# STAFF REPORT

TO:	Committee of the Whole	<b>MEETING DATE:</b> September 7, 2021
FROM:	Director of Planning	FILE NO: ZA-2021-05 & DP-2021-15

# SUBJECT: Rezoning and Form and Character Development Permit for Cluster Residential Development at Proposed Lots 37 and 38 Celia Crescent

RIGHT ELEVATION

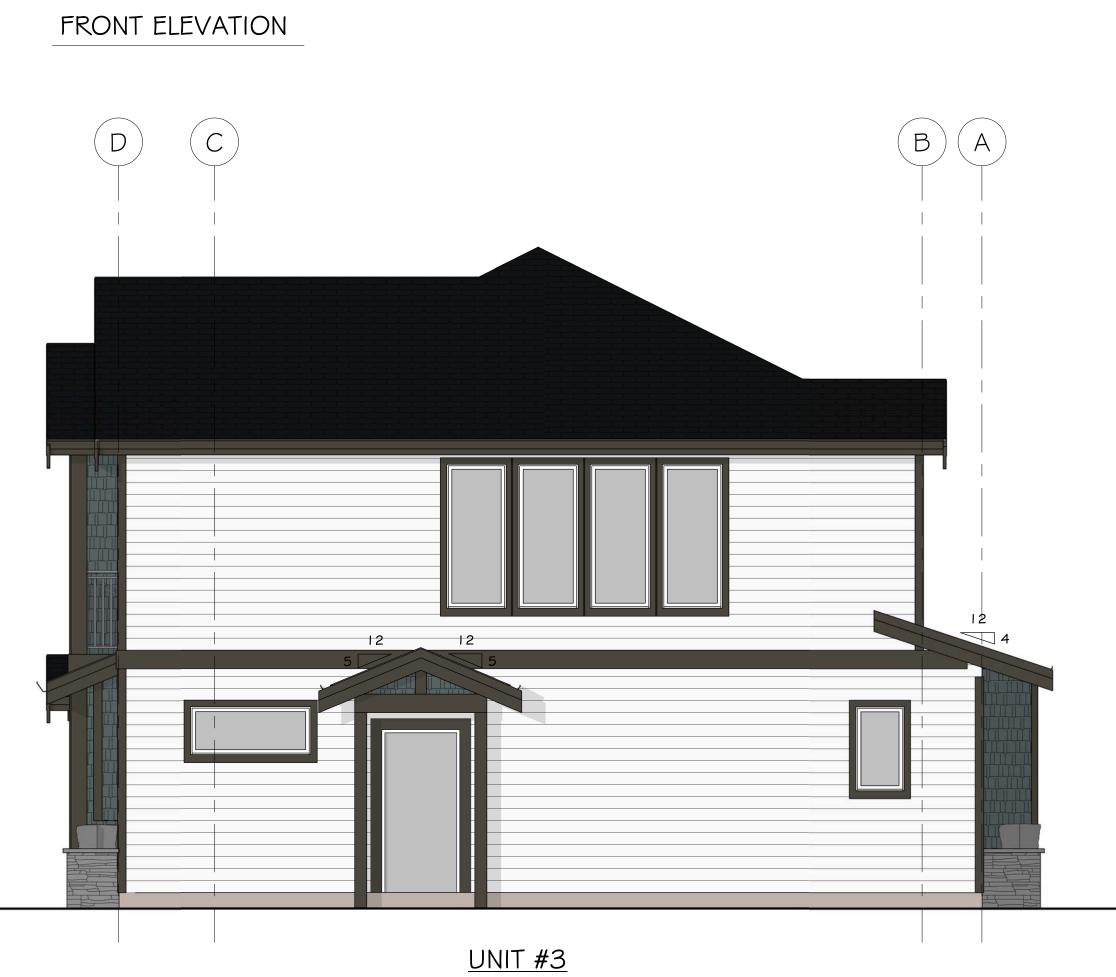
- 1. reduce massing of roof could use skylights;
- 2. mute the visual party walls use a different level of filigree (such as a softer wood panel) to make the building look more cohesive;
- 3. colour might help to differentiate the units; and,
- 4. change landscaping towards side doors to improve pedestrian access and circulation, such as use of trellises.
